**ADDENDUM NUMBER TWO**  
**CHATTANOOGA PUBLIC LIBRARY – INTERIOR ABATEMENT PROJECT**  
**CONTRACT NO. L-16-001-201**  
**CITY OF CHATTANOOGA, TENNESSEE**

The following changes shall be made to the Contract Documents, Specifications, and Drawings:

DWG A1.3

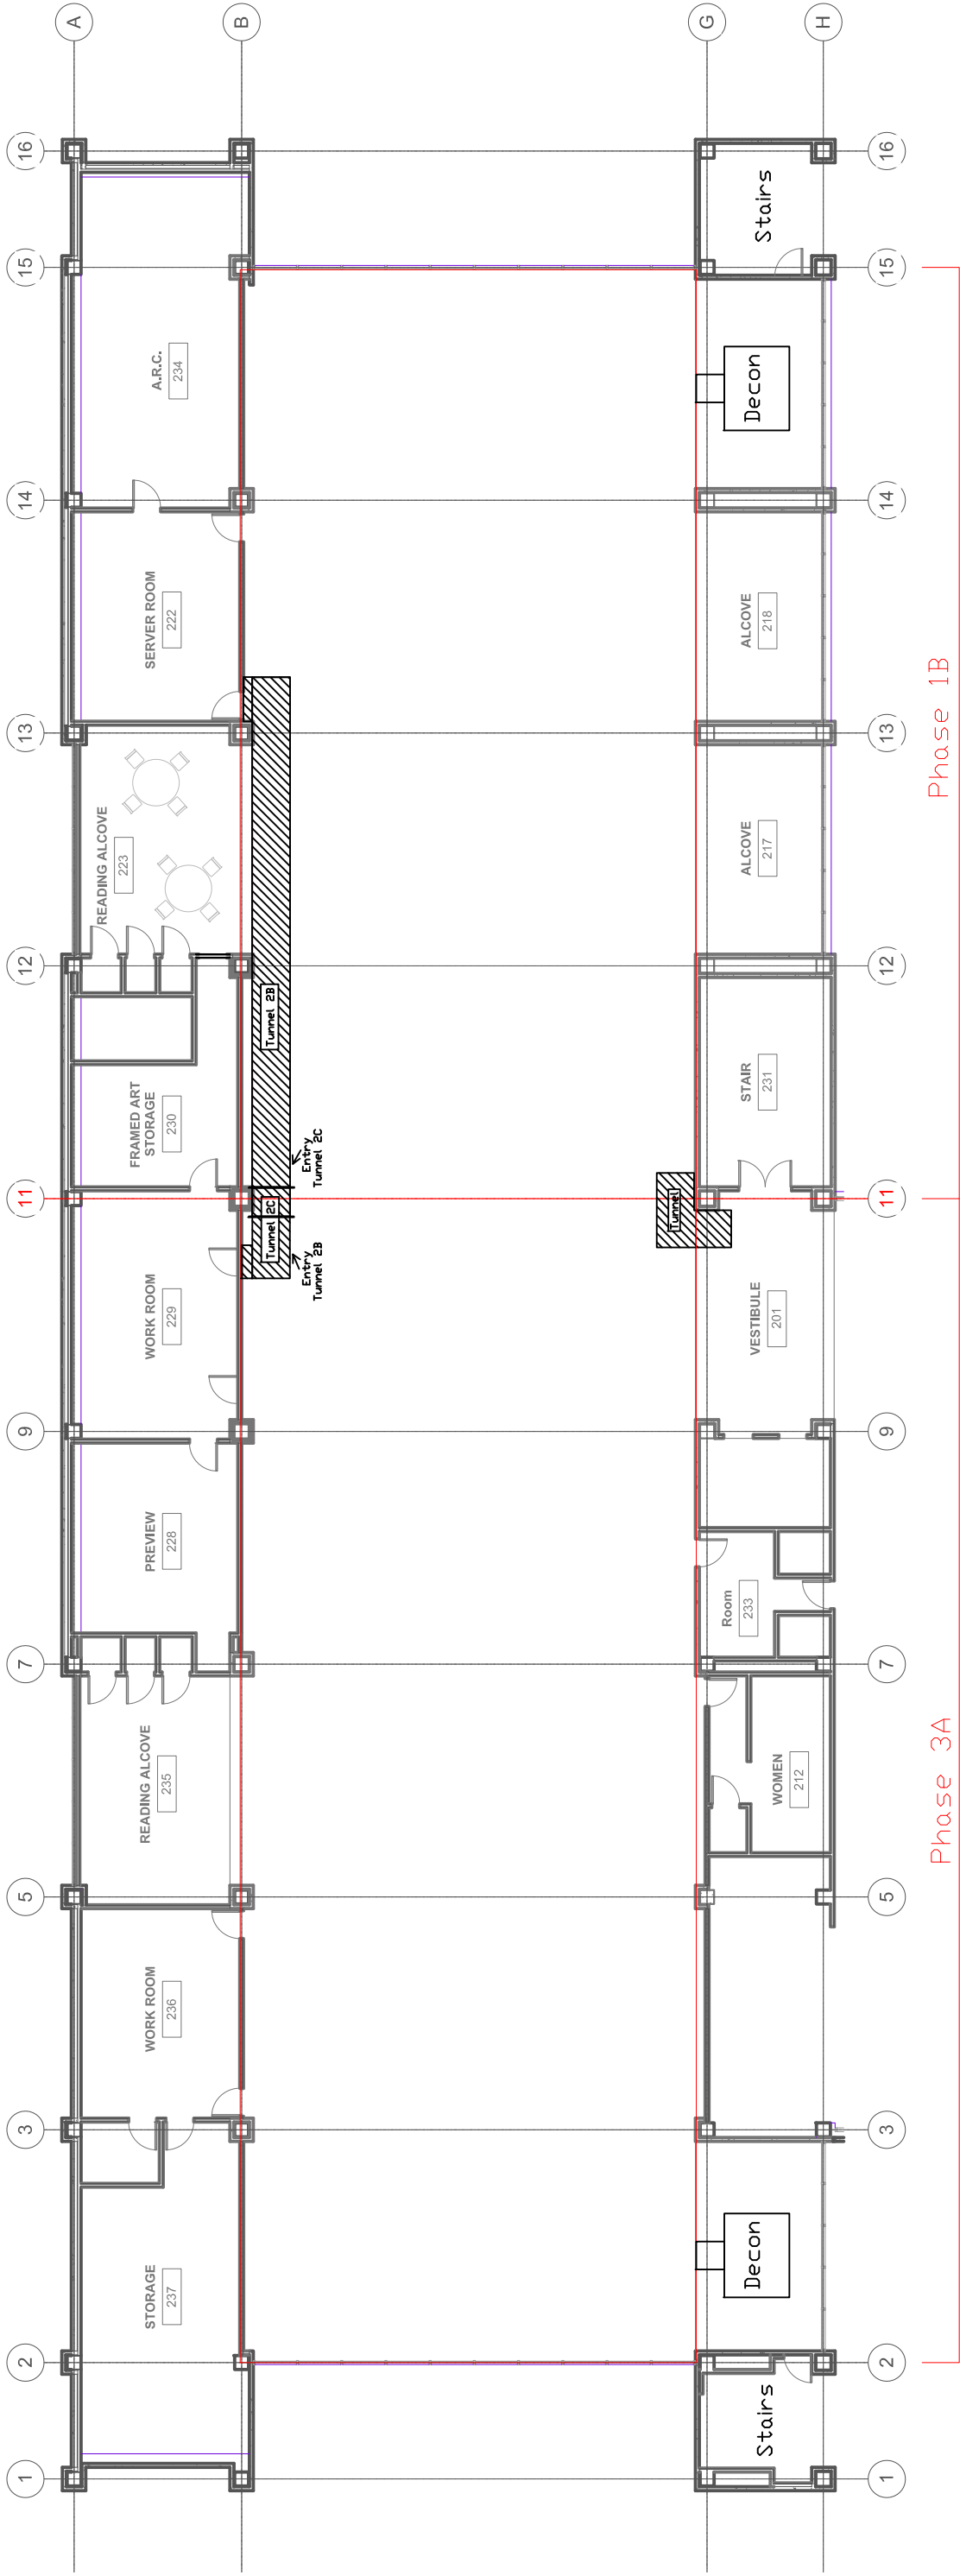
- III. Owner wishes to add additional carpet removal that is outside the containment areas. Carpet, and floor tile removal areas have been reflected in the above referenced drawings noted as 1-3, 2-3 and 3-3. Quantities reflected in section 1.1.1 of the “Asbestos Abatement Specifications” should be amended as follows and included in your base bid pricing:

Carpet & Adhesive (Yellow) Removal	36,724 SF (total)
------------------------------------	-------------------

Floor Tile & Mastic (Black) Removal	2,700 SF (total)
-------------------------------------	------------------

DWG A2.2

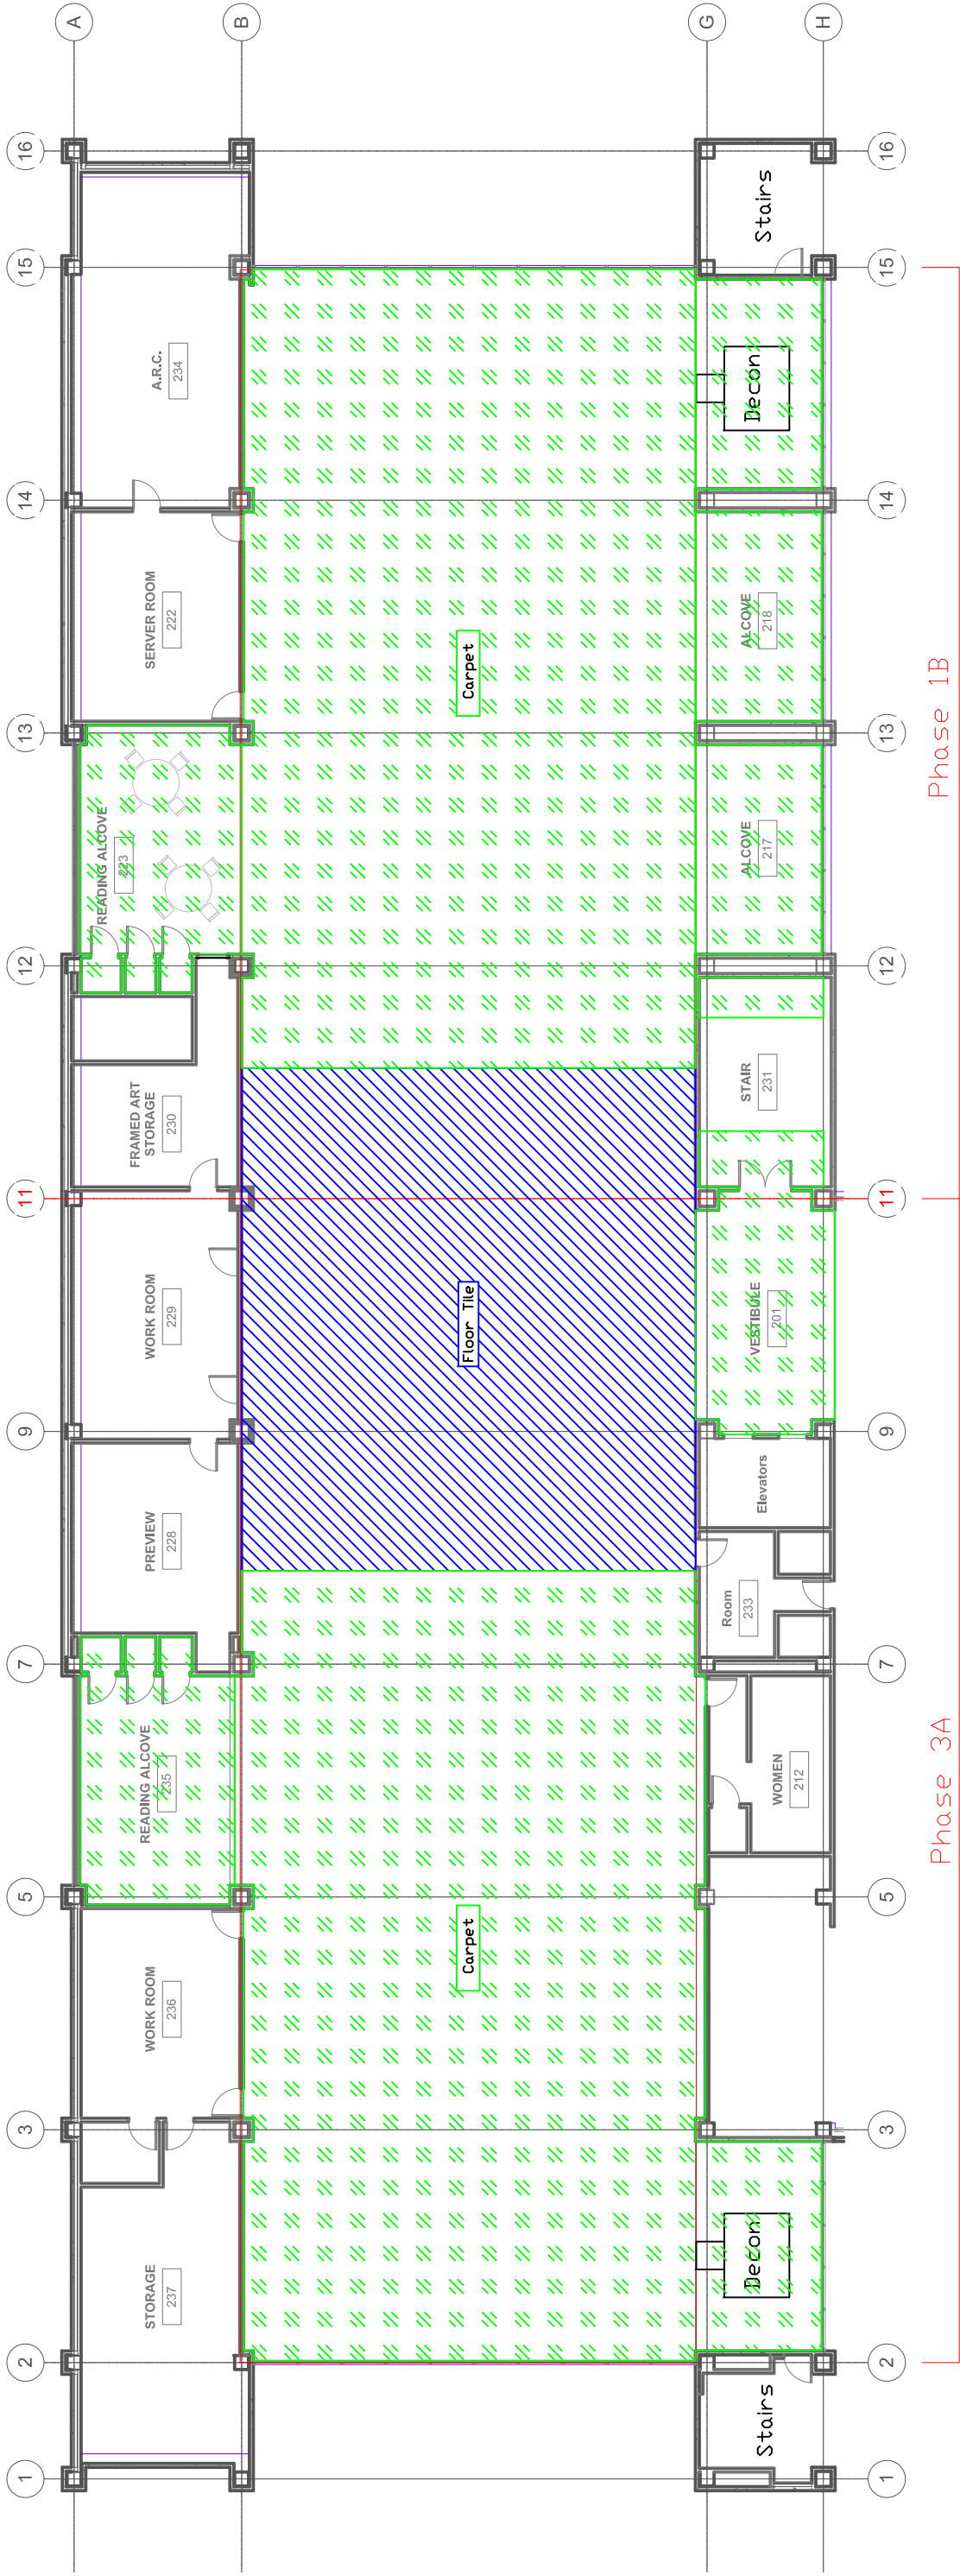
- iV. Owner wishes to add additional tunneling on the second and third floor to allow for access to work areas by employees during the abatement project. The original 90 degree tunnels from the foyers will remain. The following tunnels are in addition to the small ones noted on the original drawings. New drawings have been attached to show the additional locations. Construction of the tunnels will remain as noted in the original specifications with the addition of temporary lighting which will remain in the tunnels until they are removed.

Tunnel 2B	Installed during Phase 1B	60’ Long x 4’ wide x 8’ high
-----------	---------------------------	------------------------------

Tunnel 2C	Installed during Phase 3A	10’ Long x 4’ wide x 8’ high *
-----------	---------------------------	--------------------------------

DWG A3.2

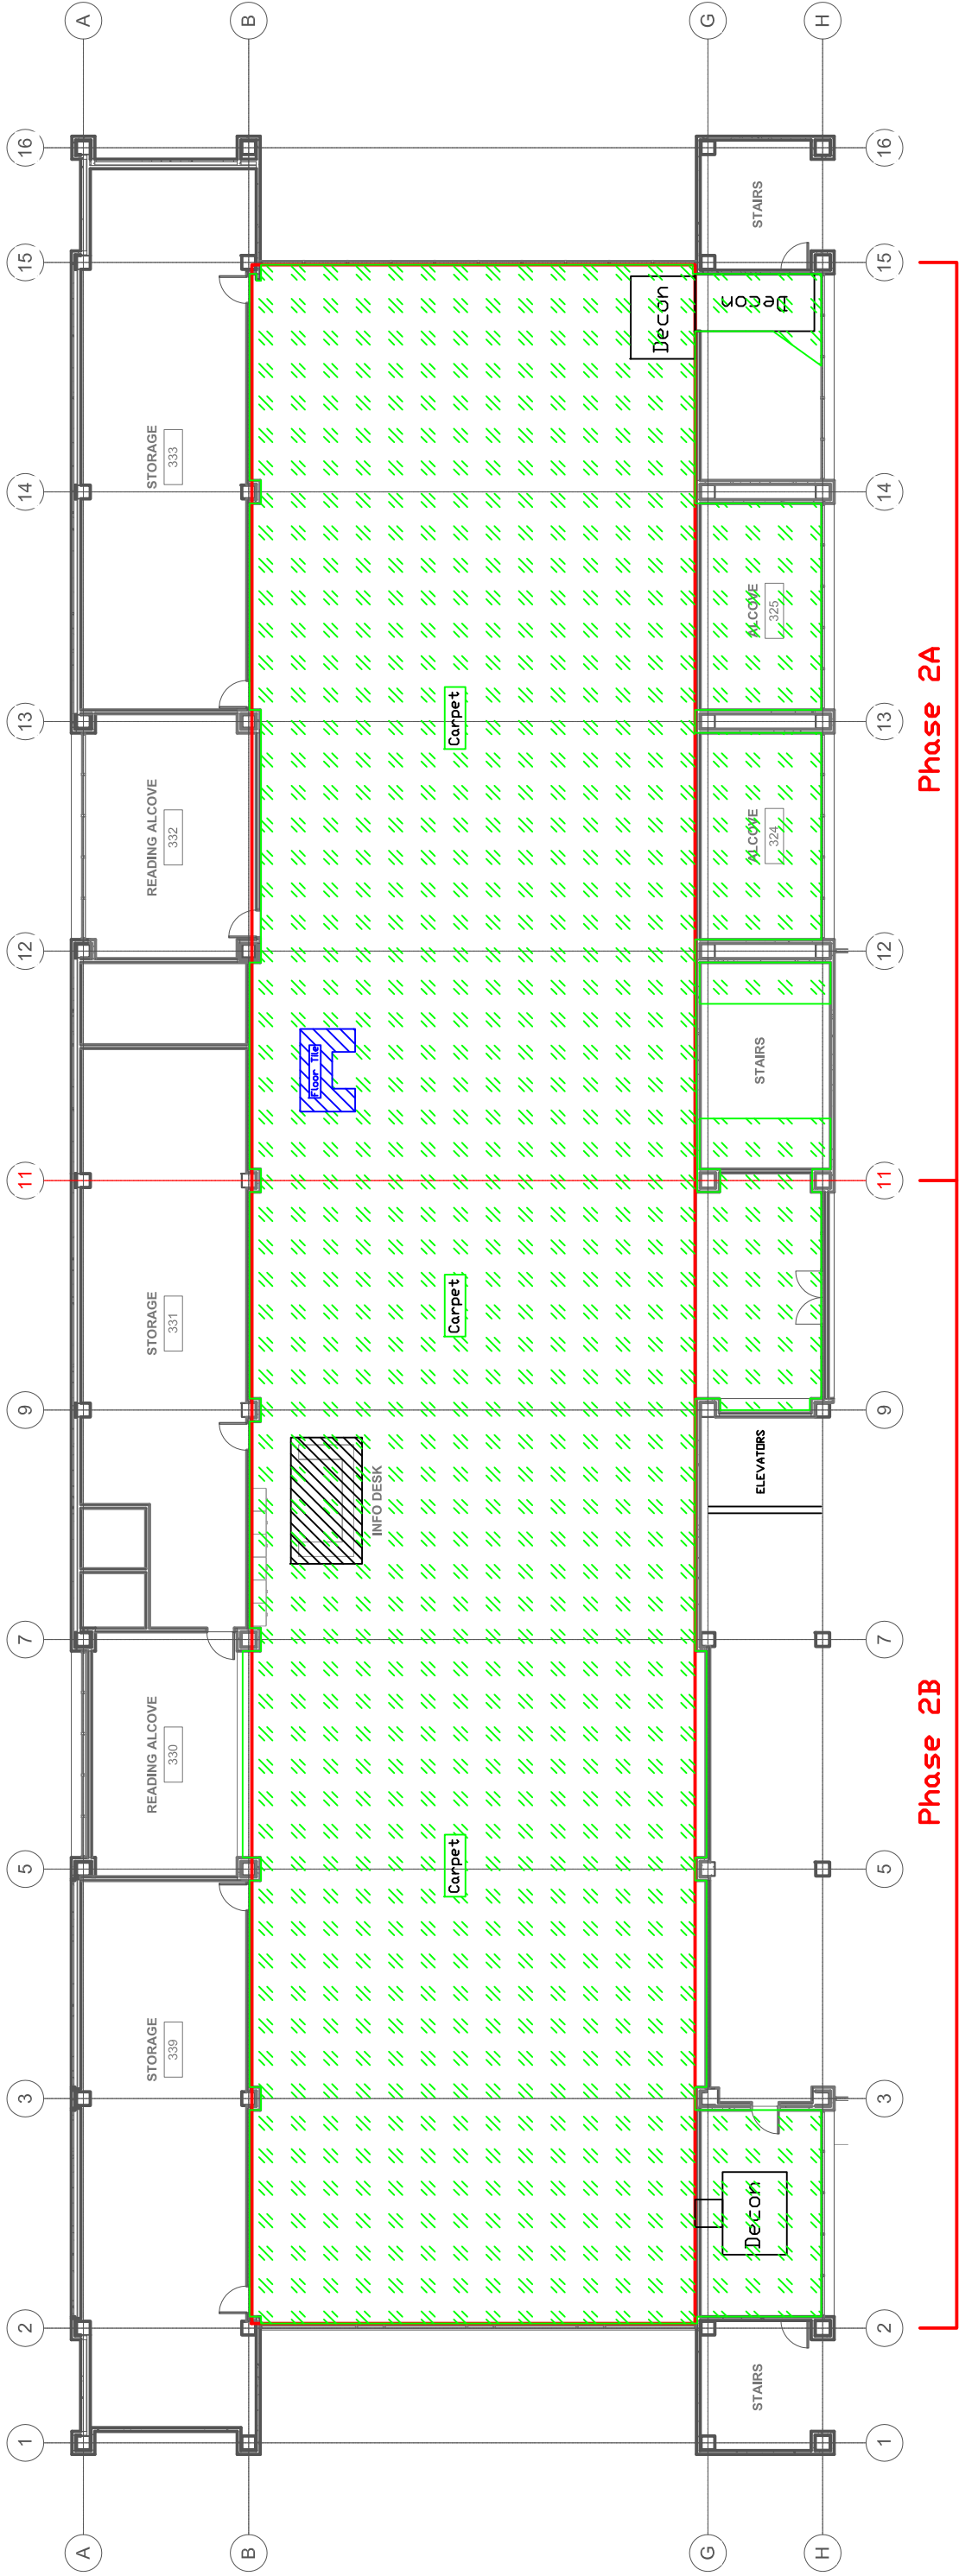
Tunnel 3B	Installed during Phase 2B	82’ Long x 4’ wide x 8’ high
-----------	---------------------------	------------------------------
